## PCN – Process Change Notification

Change:	OMB.433.B03F21
Date:	2018/04/20
Author	Bonnie Chen

Model#	Part Number	Changes
433MHz 3dBi Omni Antenna,with N Type Female Connector, U-Bolt, 523mm Length Ø70*55mm	OMB.433.B03F21	1. Change bracket from 4 holes to 2 holes.

**Illustration of Change**

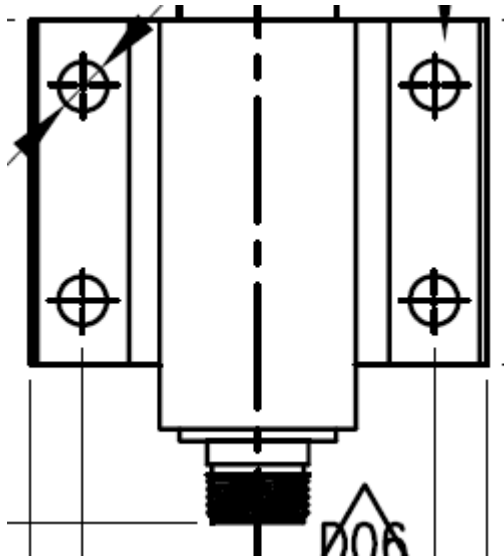
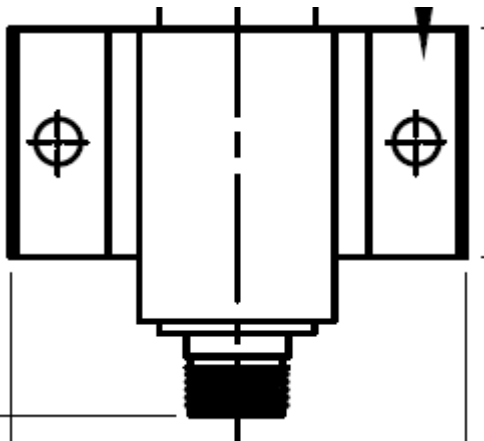
- Hardware Modification  
 Production Process Advance  
 Others –Change bracket from 4 holes to 2 holes.
-

Taoglas tested the VSWR data, we found two holes data is better than four holes. So we had been changed the bracket to get better performance.
